B.G.A. TECHNICAL COMMITTEE

TECHNICAL NEWSHEET

TNS 5/6/83

PART 1 AIRWORTHINESS 'AGGRO' Please add to the 1983 Pink Pages

SERVICE BULLETIN December 9, 1982 M20 - 26

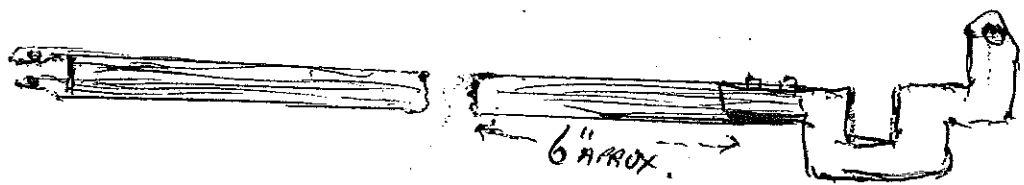
SUBJECT Rudder bottom hinge bracket.

DESCRIPTION Due to a too small bending radius of the hinge bracket suspension flange, fractures have been found on the corners of the hinge suspension flange. The vibration caused by a hard rubber tail dolly wheel may in some cases assist in the formation of the fracture. It is possible that when the fractures get large enough the bottom hinge could peel off and jam the rudder control.

- cadmium, yellow colour
 - zinc, clear
- 3) Make and weld the bracings on the suspension flange according to the drawing. NOTE! Weldings can be done only by a person who has an aircraft welding licence. Before assembling the hinge bracket has to be sand blasted, the attaching holes has to be drilled and the whole bracket has to be coated (cadmium or zinc) and painted.

VIEW LOOKING AFT ON FLAP DRIVE TORQUE TUBES ASSY.

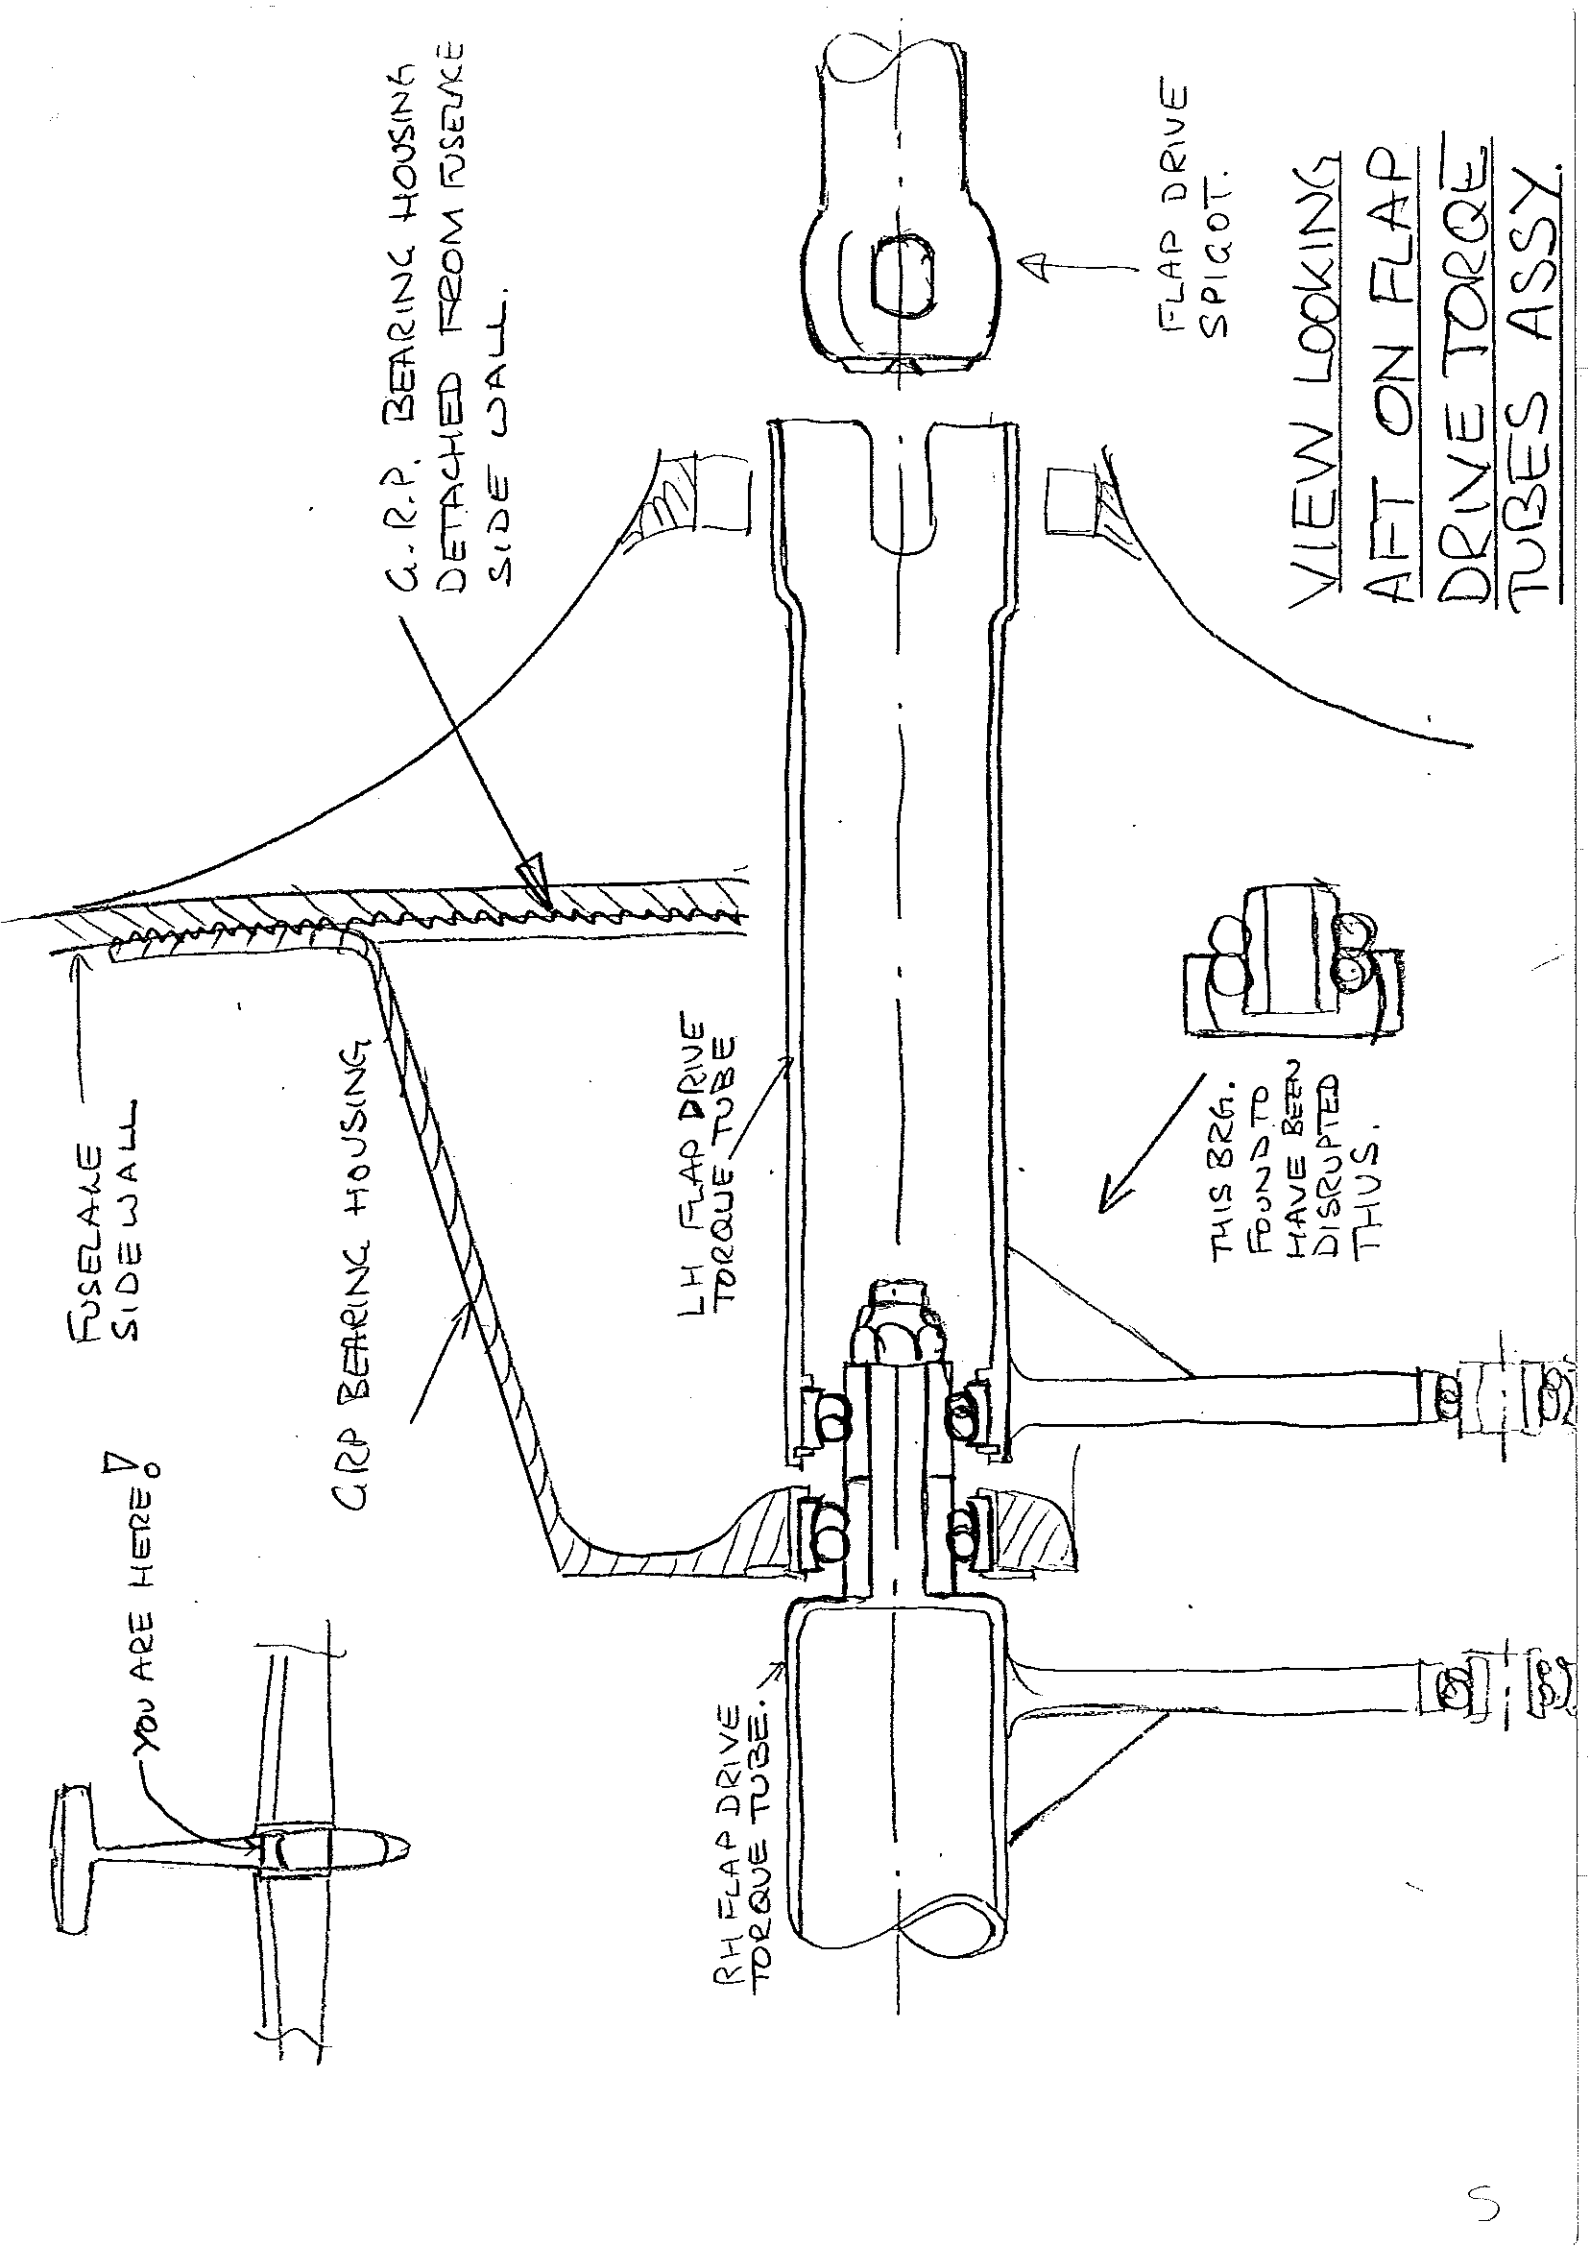
After the event the g.r.p. moulding which provides the flap torque shaft bearing was found to be almost completely detached from the inside of the fuselage. The resulting flexibility provided enormous flap backlash. On dismantling the mechanism the double row self aligning bearing at the end of the L.H. torque tube was found to be disrupted as shown in sketch.

The L.H. flap drive bearing has received a substantial overload in the inwards direction to cause the outer ring to spring over the ball array. This load can only be reacted by the g.r.p. moulding carrying the centre bearing in a direction which will "unpeel" it from the fuselage wall. It is suggested that the L.H. wing was entered to the fuselage with the flap in a different position to that of the cockpit lever. The flap drive spigot then abutted the slotted end of the torque tube instead of entering the slot. The resulting end load disrupted the bearing and dismounted the g.r.p. bearing housing.

THIS BRG. FOUND TO HAVE BEEN DISRUPTED THUS.

1. That owners be alerted to the risk of damage during rigging.
2. That inspectors be made aware of the possibility that such damage could exist.
